# PRODUCT CHANGE NOTIFICATION (PCN)

**PCN Number:** SAP406107  
**Title:** Removal of sensor side-fill  
**Product Family:** Dart usb  
**Release date:** June 25, 2018  
**Contact:** Basler Support  
**Type of Change:**  
 **Miscellaneous**  **Firmware**  **PC Software**  
 **Product design**  **Process**

## Change Description

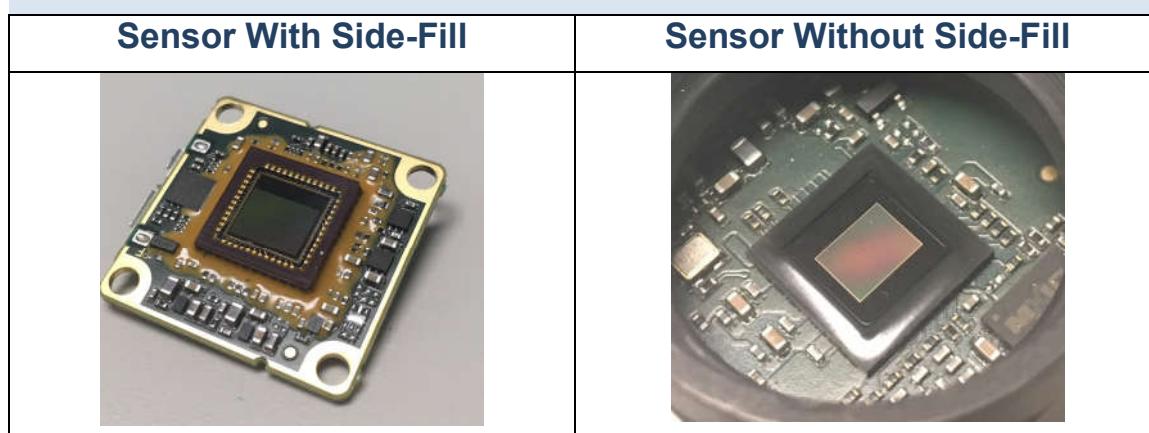
Due to product improvements, the side-fill previously found around the imaging sensor is no longer needed. Fit / form / function are not affected.
